Loreto Kirribilli State Significant Development Application

Response to Submissions

85 Carabella Street, Kirribilli
Concept Proposal and Stage 1 Development
Application

Submitted to Department of Planning and
Environment

Figure 1 Section showing the 12m LEP height limit in blue and the extent of the proposed encroachment

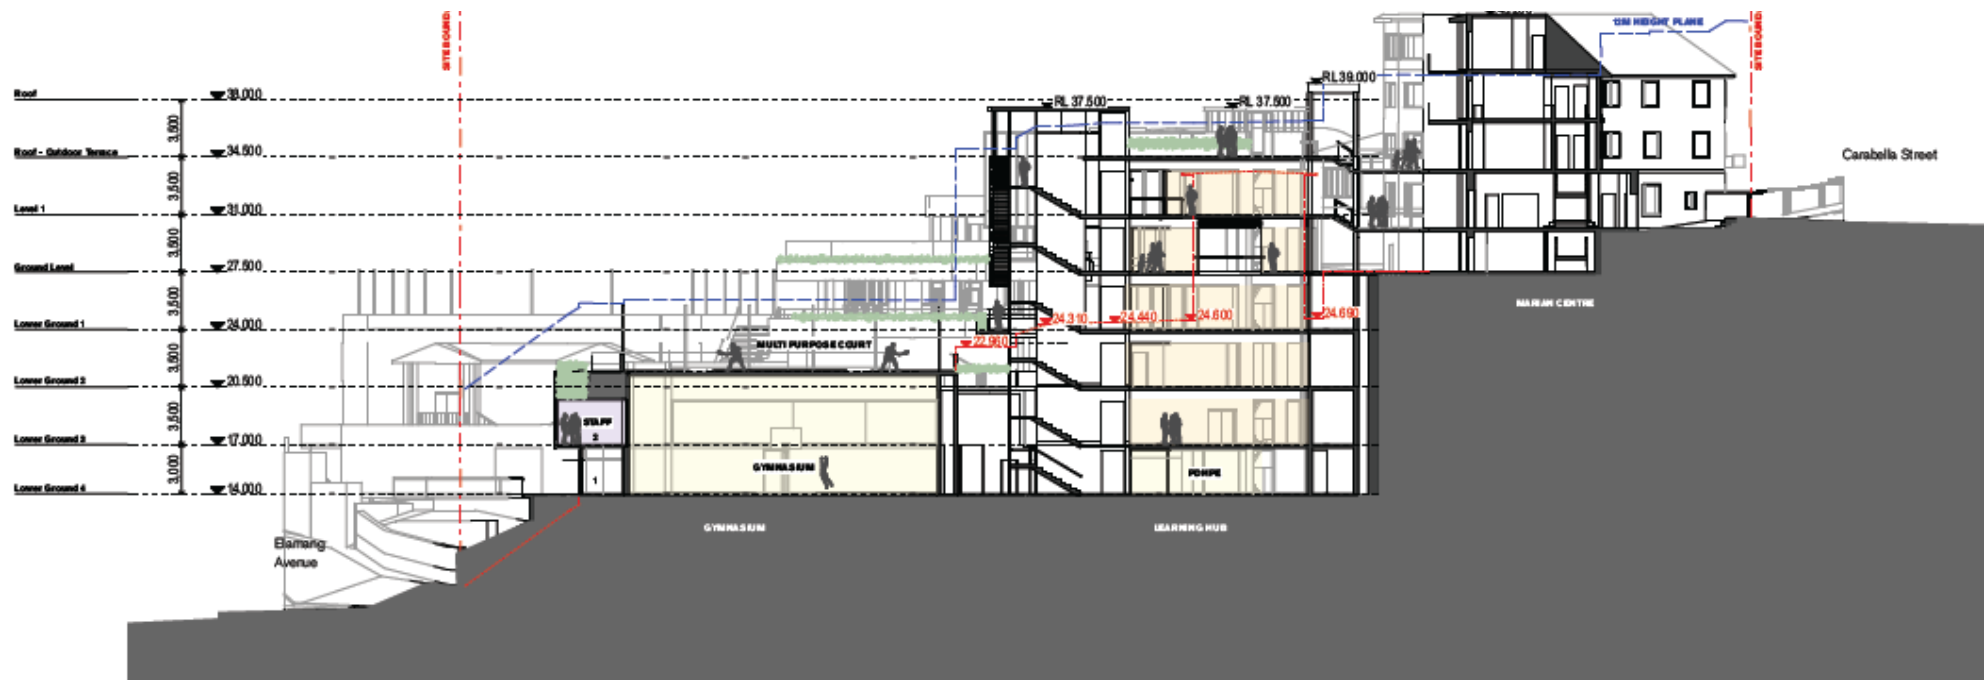
- The proposed seven storey Learning Hub, which exceeds the permissible height limit and has adverse impacts on views currently enjoyed by the residents of the east facing units at 111 Carabella Street. The height exceedance is primarily due to the lift overrun and the fire stair well which provide access to the rooftop terrace. Insufficient information has been provided regarding the need for the terrace or the details of its usage.

- Given this, it is considered that the rooftop terrace should be deleted and the height of the fire stairs / lift overrun reduced to avoid height non-compliances wherever possible. Further design changes should also be undertaken to improve the views and solar access to the affected units.

The new Learning Hub has a maximum height of RL 37.50 (14.5m). Whilst the majority of the building is within the 12m height limit, due to the topography of the site, encroachments above the 12m LEP height standard are proposed to accommodate the plant, lift overrun and stair (refer to **Figure 1**). This represents a variation of 2.5m above the 12m height limit which applies to this part of the campus.

The Department has suggested that the accessible roof terrace be removed to enable the lift overrun and stair to be reduced to sit within the LEP height limit. The importance of the rooftop terrace and connections between the Learning Hub and Marian Centre to the operation of the new development are discussed further at Section 2.3.

Figure 2 Relationship between 111 Carabella Street (left) and the proposed Learning Hub

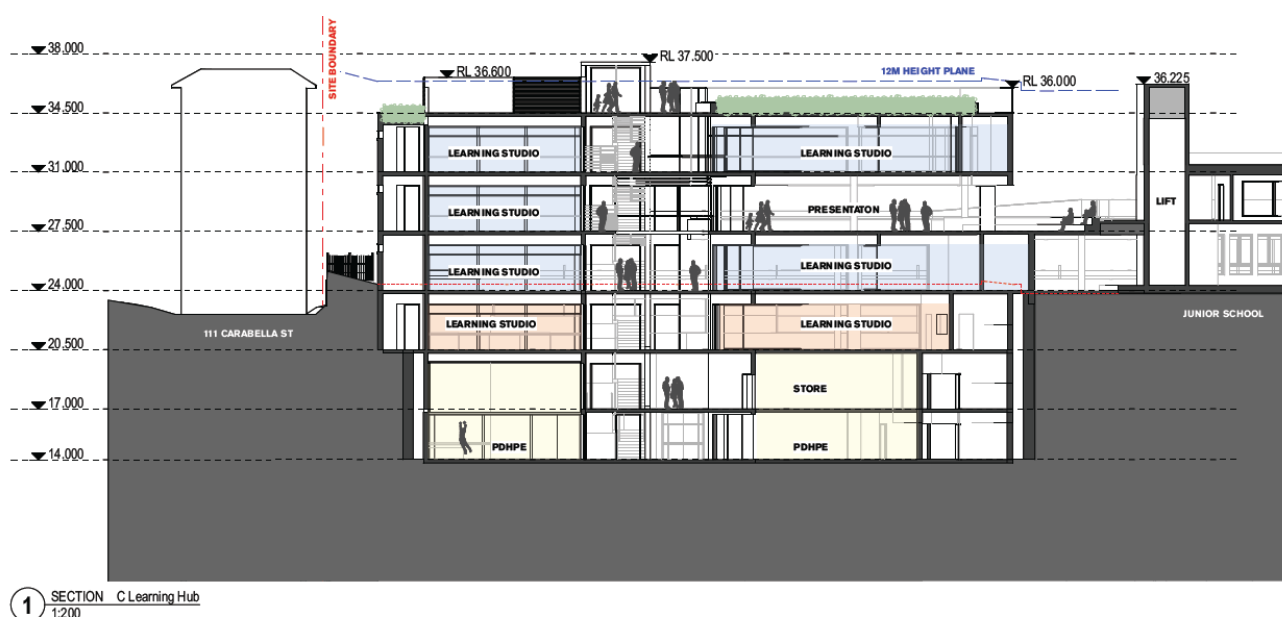
- The scale of the new buildings, particularly the new additions to the western building (Learning Hub), located close to the adjoining boundary site are incompatible with the sites adjoining and opposite along Carabella Street and Elamang Avenue.

- It is only two storeys above street level (Carabella Street) and is lower than the existing Marian Centre when viewed from Carabella Street.
- The Learning Hub is well within the height of the School Chapel, which sits at approximately 24.7m.
- The land immediately to the west of the campus (at the interface with the Learning Hub) is zoned R4 High Density Residential. The proposed Learning Hub is consistent with the scale of the apartment building immediately to the west at 111 Carabella Street, as shown in the Section at **Figure 2**.

Figure 4 Oblique (worst case) and total views from W21

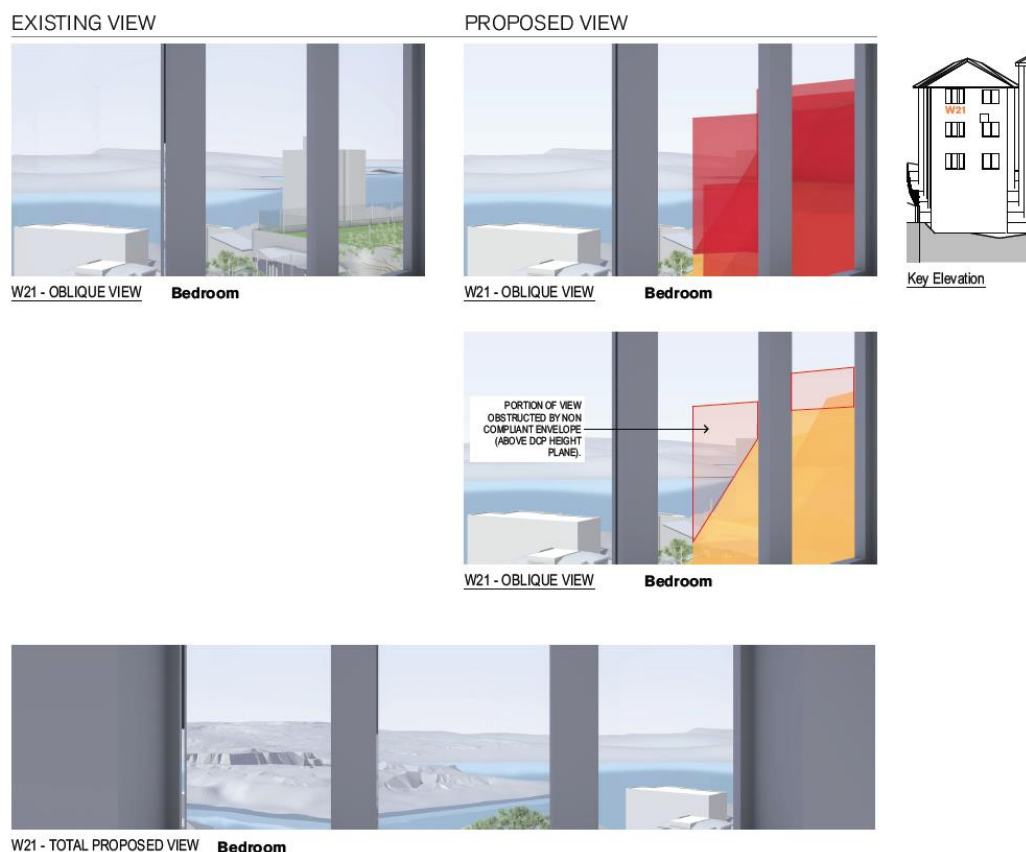
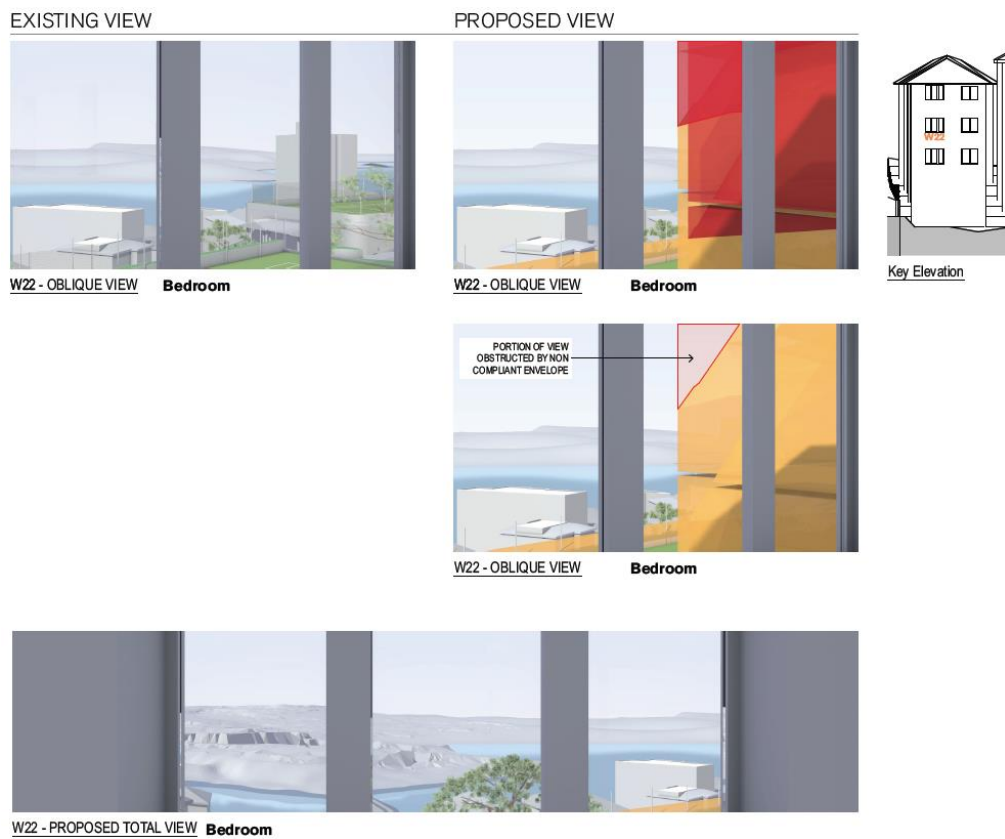
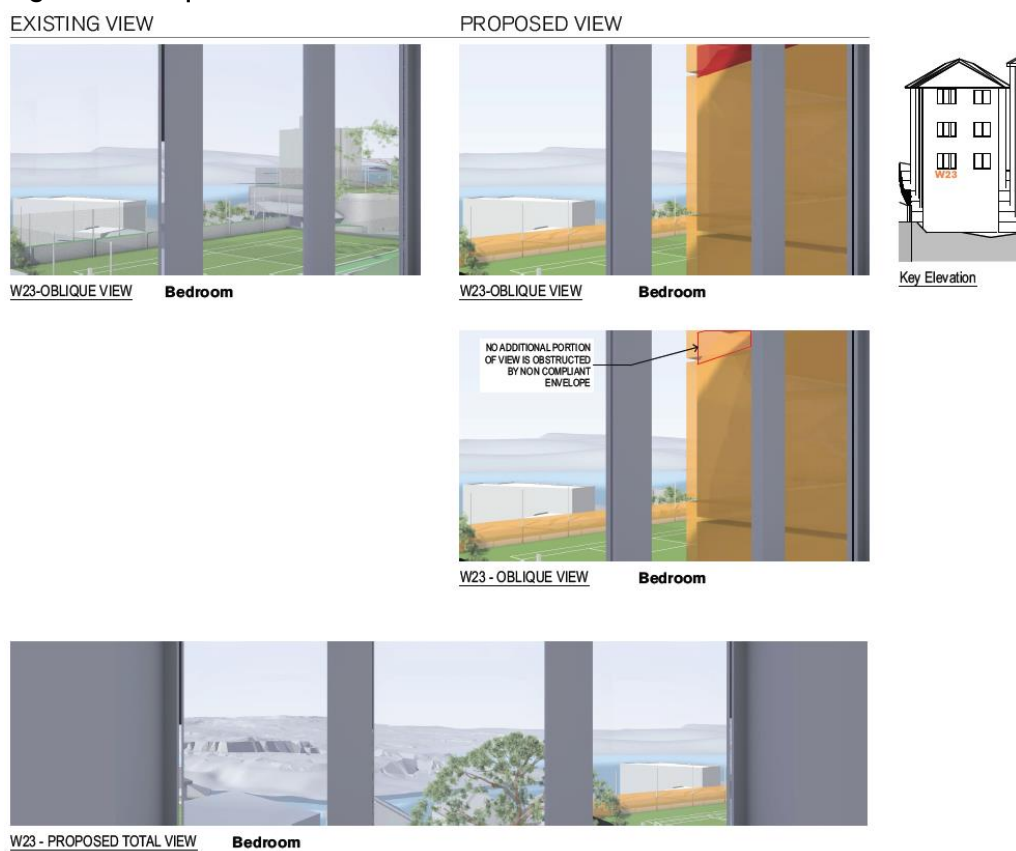
- The impact on views and amenity to the neighbouring apartments where the view loss is a result of proposed heights over the LEP / DCP maximum heights should be removed.

- The applicant should seek to reduce the impact on views and amenity where the proposed buildings are within the limitations of the LEP / DCP height maximums.

View impacts from the north facing apartments were tested from a number of angles to assess the overall view loss. Refer to the **Figures 4 – 6** and attached drawing sheets SKMP-60.1/SKMP-60.2 at **Appendix C** for further details.

Figure 4 shows view W21, taken from a worst case view point looking obliquely across the school site. However, when looking directly out of the window (the total view) there is no impact to the existing views. The same applies to W22 and W23 (**Figures 5 and 6**) which show that the proposal will have no, or minimal, impact on total views.

As illustrated below, the loss of views as a result of the non-compliance (shown in red) is considered to be relatively minor when considering both the total view and the oblique view - W21 shows a small

portion of harbour view loss and W22 shows a small portion of sky loss from the non-compliant envelope. From W23, the non-compliant envelope does not result in any additional view loss. It is important to note that these non-compliances relate to the DCP, rather than the LEP. As detailed above, SSD applications are not required to comply with the provisions of a DCP.

Figure 7 Original proposal (left) and amended proposal (right) showing the changes made to the Learning Hub as a result of the community consultation process

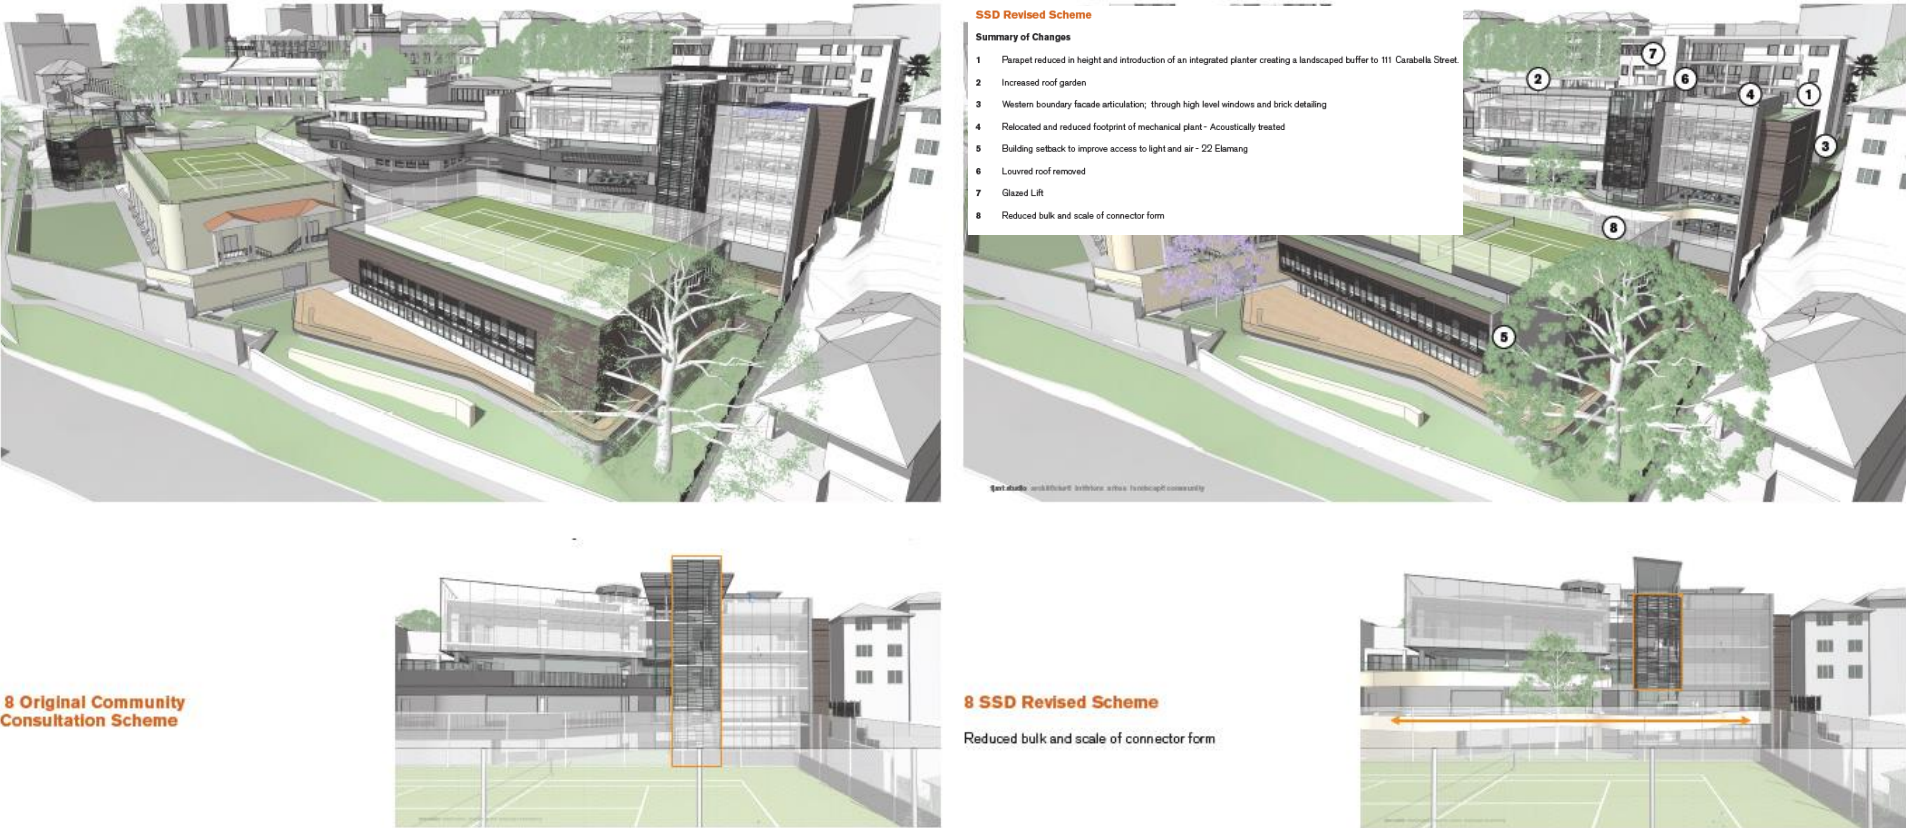
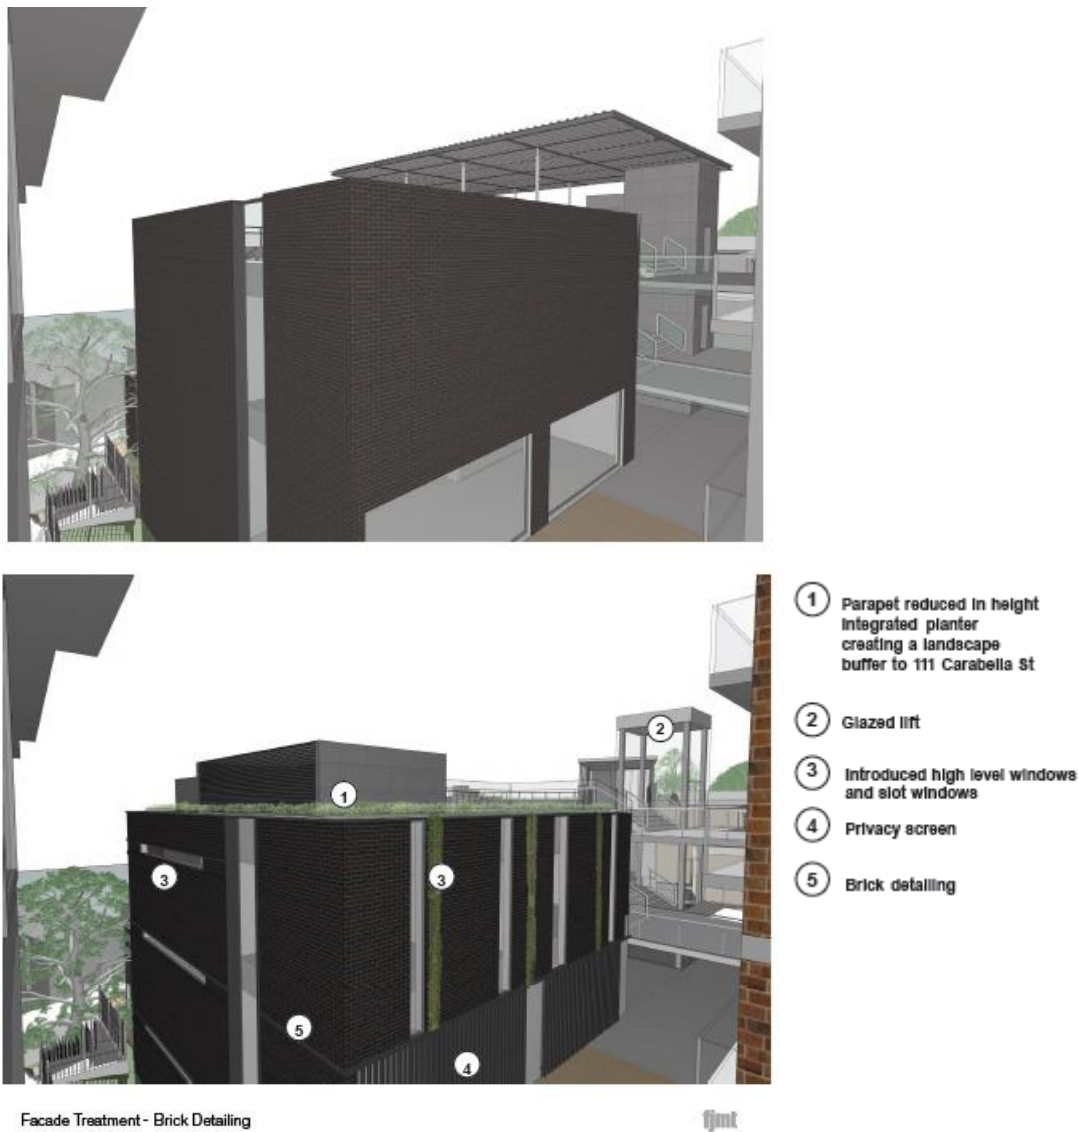
Several submissions have raised concerns regarding the proposed built form, and associated view loss and amenity impacts. Concerns primarily relate to the Learning Hub in the Western Precinct, however issues were also raised around the new envelope in the Eastern Precinct. Issues raised include:

In response to the concerns raised during the community consultation process, numerous changes were made to the design of the Learning Hub to minimise the visual impact of the building from 9/111 Carabella Street. These changes demonstrate the efforts that the applicant has made to reduce the impact on views and amenity. The changes are shown at **Figures 7** and **8** and include:

- Mechanical plant has been redistributed from the roof, enabling the roof plant enclosure to be reduced in size. The roof plant enclosure has been relocated to enable an improved outlook from the eastern side of 111 Carabella Street;

- A landscaped planter has been integrated into roof, reducing the height of the building at the western boundary and creating a green buffer between the Learning Hub and 111 Carabella Street;

- The rooftop garden has been maximised to improve outlook to 111 Carabella Street;
- Solar panels have been removed to reduce the extent of the mechanical plant enclosure;

- The louvred roof structure has been removed to improve sky view loss and visibility across the terrace;
- The lift shaft materiality has been changed to glazing in order to improve transparency and make it less obtrusive;

- High level and slot windows have been introduced to provide greater articulation to the brick boundary wall whilst still ensuring privacy between 111 Carabella and Loreto Kirribilli; and

- An improved façade treatment has been adopted for aesthetic purposes.

Figure 9 Additional view impact analysis from 46 Carabella Street

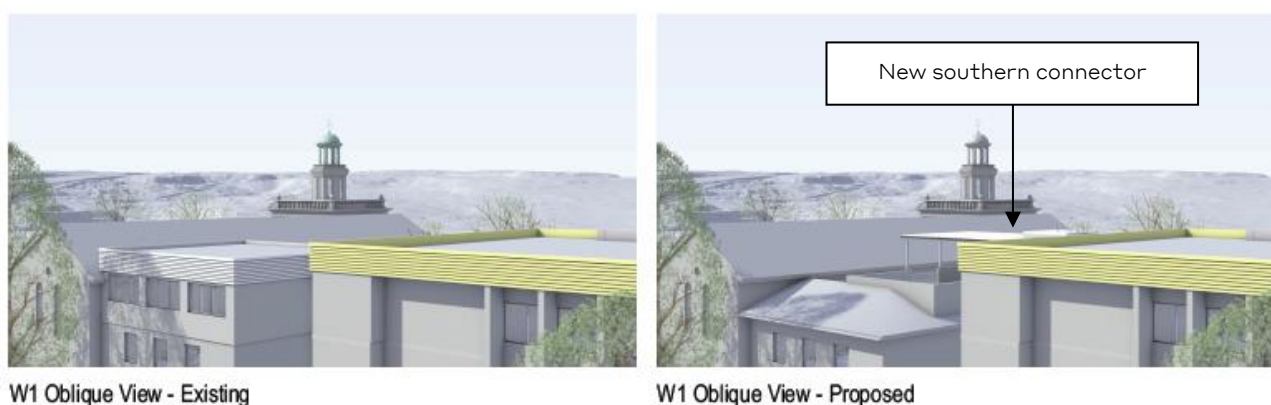
The Department also requested that greater consideration be given to the visual impact of the connector within the Southern Precinct on the views from 46 Carabella Street.

The View Impact Analysis has been updated to address the visual impact of the Southern Precinct connector on 46 Carabella Street. The additional view analysis at **Appendix C** and **Figure 9** demonstrates that the connector will sit below the ridgeline of the Chapel, and will not result in any view impacts.
